**From:** [REDACTED]  
**To:** [Norfolk Boreas](#)  
**Cc:** [REDACTED]  
**Subject:** HHPC response for 20th August deadline  
**Date:** 17 August 2021 06:39:01  
**Attachments:** [17F4143B566A44658FAAC969683FB22E.png](#)

## 8.27 Onshore Project Substation Masterplan

F&OBO Holme Hale Parish Council

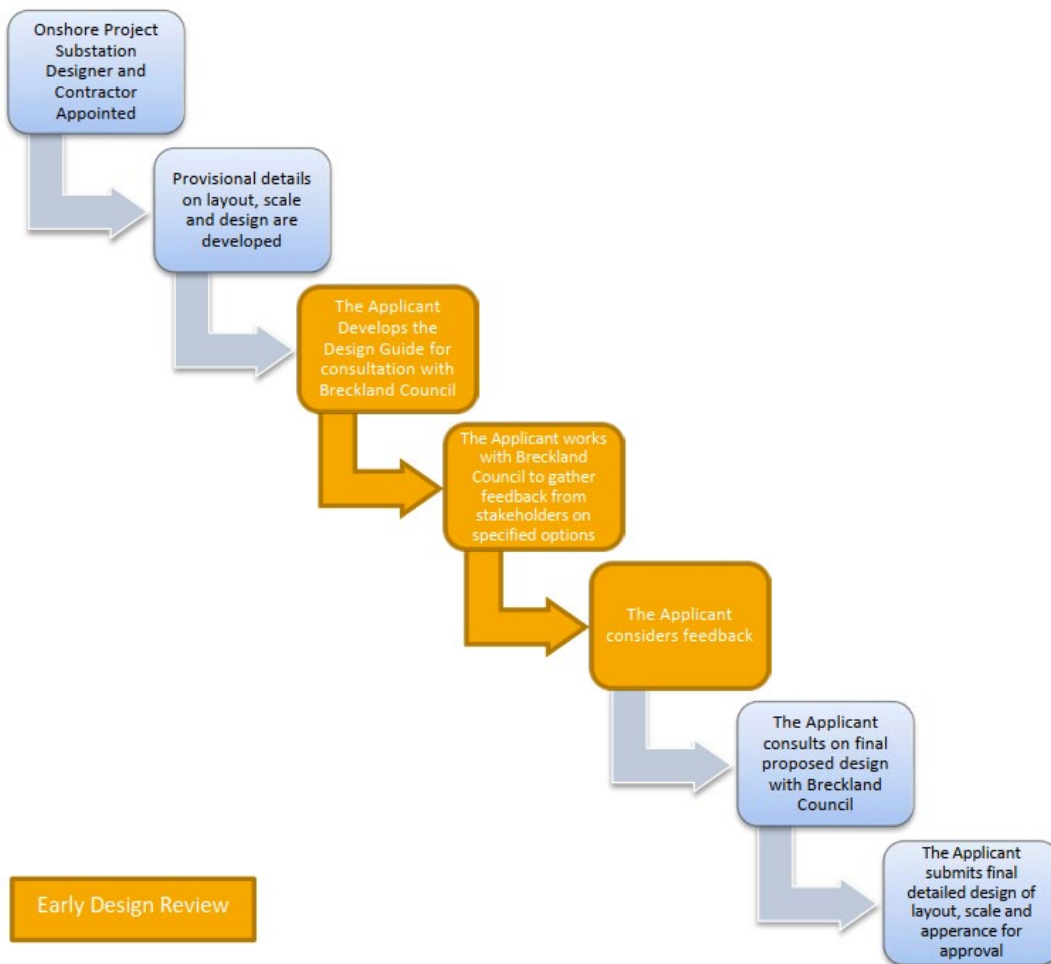
The schematic from that section of the document clearly shows that provisional details of layout, scale and design will be determined BEFORE their design guide is written... this allows the applicant to make their design guide fit the layout & design and NOT, as it should be, for the layout and design to fit the design guide.
